Item Name: Crosstube Turning Detail

Draw Nbr	Revision Nbr
D407-667-145	Rev C

DRAWING NO. D407-667-145	TITLE CROSSTUBE ASS'Y (407 HIGH FWD)	REV. C	DART AEROSPACE LTD ENGINEERING ORDER		D.E.O. NO. D407-667-145-C-1	SHEET NO. SHEET 1 OF 1	SCALE NTS
DRAWN 97	CHECKED ASS	MFG. APPR. BS	APPROVED WD		DE APPR. H		
DATE 11.07.15	DATE 11.07.22	DATE 11.07.22	DATE 11/07/22		DATE 11.07.21

DRAWING NO. D407-667-145	TITLE CROSSTUBE ASS'Y (407 HIGH FWD)	REV. C	DART AEROSPACE LTD ENGINEERING ORDER	D.E.O. NO. D407-667-145-C-2	SHEET NO. SHEET 1 OF 1	SCALE NTS
DRAWN AJS	CHECKED -	MFG. APPR. E	APPROVED 140	DE APPR. H		
DATE 12.08.02	DATE 12.08.02	DATE 12.08.02	DATE 12.08.02	DATE 12.08.02	DATE 12.08.02

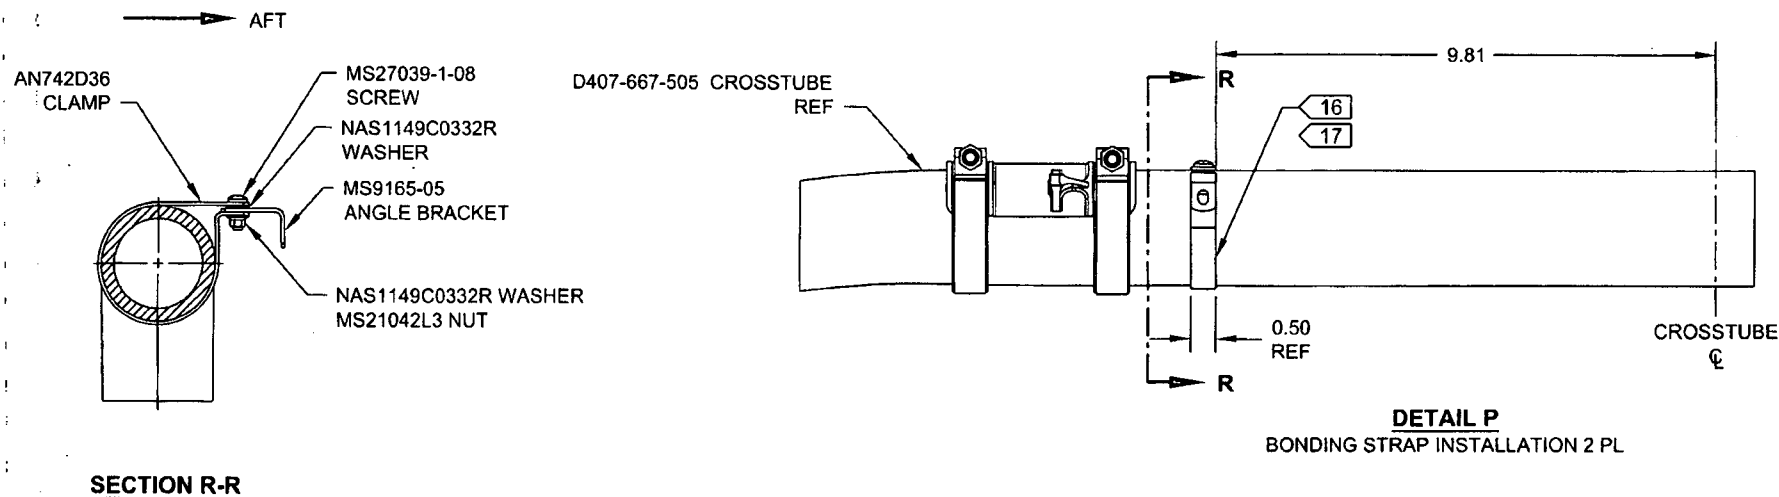
ADD ELECTRICAL GROUNDING STRAP

ITEM	QTY	PART NUMBER	DESCRIPTION
1	X	D407-667-145	CROSSTUBE ASSEMBLY (407 HIGH FWD)
10	2	AN742D36	CLAMP
11	2	MS9165-05	ANGLE BRACKET
12	2	MS21042L3	NUT (OR MS21042-3)
13	2	MS27039-1-08	SCREW
14	4	NAS1149C0332R	WASHER (OR AN960C10L)

- 16) MASK AREA UNDER CLAMP PRIOR TO PAINTING
- 17) SEAL EDGES WHERE AN742D36 CLAMP MEETS WITH THE CROSSTUBE USING SIKAFLEX-241/-291 OR MIL-S-8802 CLASS B2 OR PROSEAL 890 SEALANT
- 18) PERFORM RESISTANCE CHECK TO ENSURE MAX RESISTANCE IS 10 MILLIOHMS
